January 15, 2016

Re: United Heckathorn Superfund Site, Richmond, California

This technical memorandum presents a review of the Draft Focused Feasibility Study (Draft FFS) recently issued by the U.S. Environmental Protection Agency (USEPA) for cleanup measures at the Former United Heckathorn site in Richmond, California (Site; Figure 1). The Draft FFS presents the development and analysis of remedial alternatives for marine sediments that continue to be impacted by various contaminants of concern in the Lauritzen Channel (referred to herein as "the Channel"), following an initial cleanup attempt in 1996 and 1997.

Figure 9
Conceptual Confined Disposal Facility (CDF) Area
Engineering Review of Draft FFS
Former United Heckathorn Site, Richmond, California

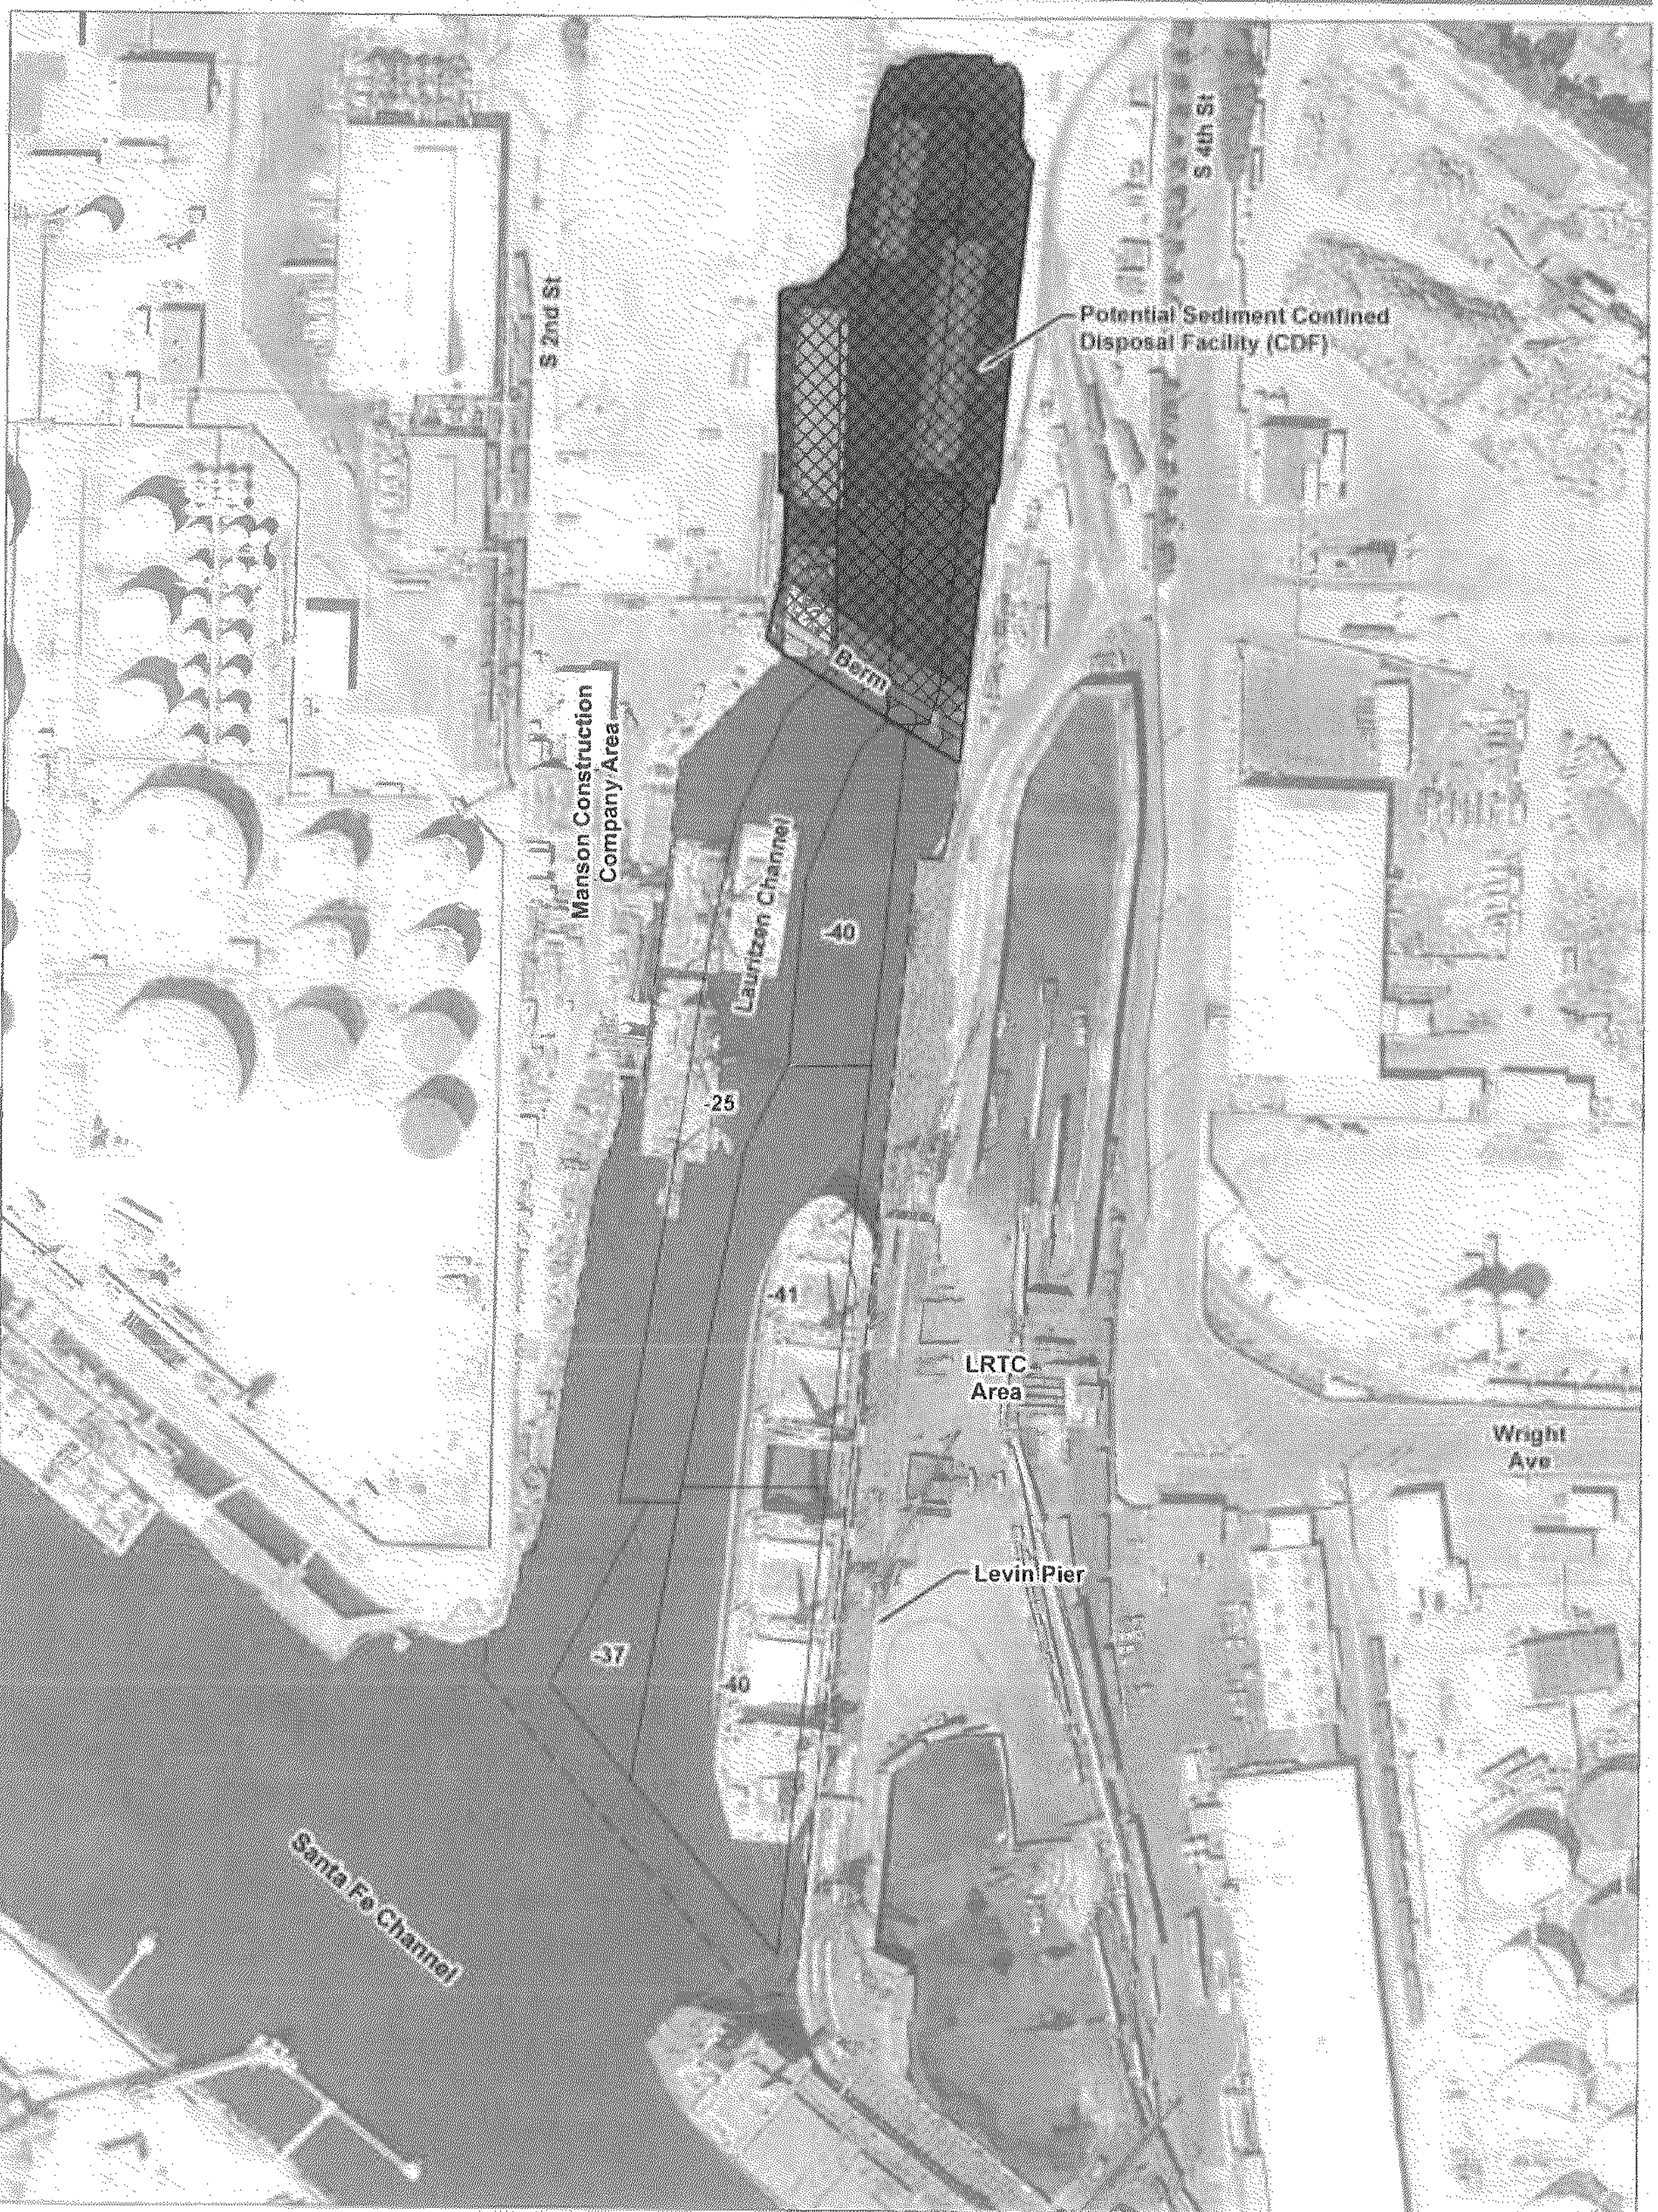
A conceptual CDF at the Site, depicted on Figure 9, would be located in the Northern Head of the Lauritzen Channel. Sediment could be placed behind a retaining berm built across the channel, north of the Levin Pier, using sand/gravel fill and armoring rock on the face. This conceptual geometry would result in the filling of approximately 2 acres. Approximately 40,000 cy of sediment could be placed behind the berm to a top elevation of +1 feet MLLW, while the remaining dredged material would be disposed off-site. Another 15,000 cy of sediment would be confined in placed beneath the CDF. By capping the area with clean fill to match surrounding grades, usable land area could be created.

The CDF depicted on Figure 9 would provide cost savings by avoiding transportation and disposal of sediments at a distant or out-of-state upland facility. In addition, the CDF permanently confines existing sediments within its footprint, further reducing the volume of sediment that might require dredging, transportation, and disposal.
